SERVICE BULLETIN

Bulletin Number: 731419-B1

Product: F1 Model 812 Loudspeaker

Subject: Potential array latching issue due to foam compression issues.

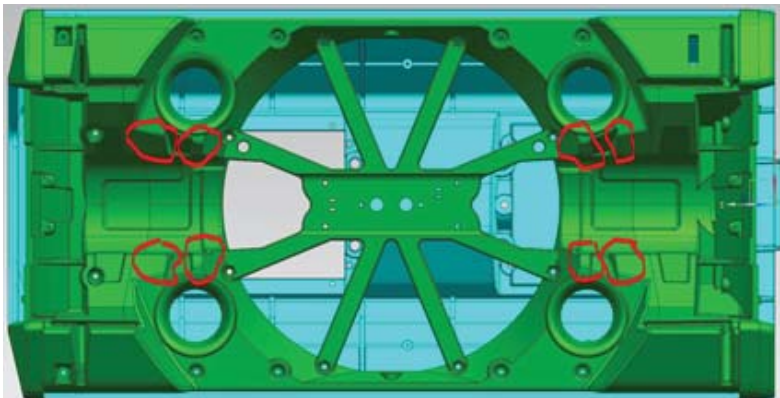
Symptom: Speaker may not reliably latch in the C, J or reverse J positions.

Reason: Foam used in earlier production units may prevent consistent latch.

Solution: Perform the rework procedure below.

1. Fully unpack unit.
2. Place unit on its back on a soft cushion on a flat surface to prevent damage during rework.
3. Adjust the array to the straight configuration.
4. Remove the side grilles. Using a flat plastic tool or the hook tool, move the grille sides away from the loudspeaker enclosure until the retaining tabs are clear of the enclosure. There are four retaining tabs per grille. Take care to not damage the loudspeaker enclosure or the side grille. Once the retaining tabs are clear, pull the side grille straight off from the front of the enclosure.
5. You will be removing the foam as shown below. The foam is located at two locations at the top of each port, for a total of eight.
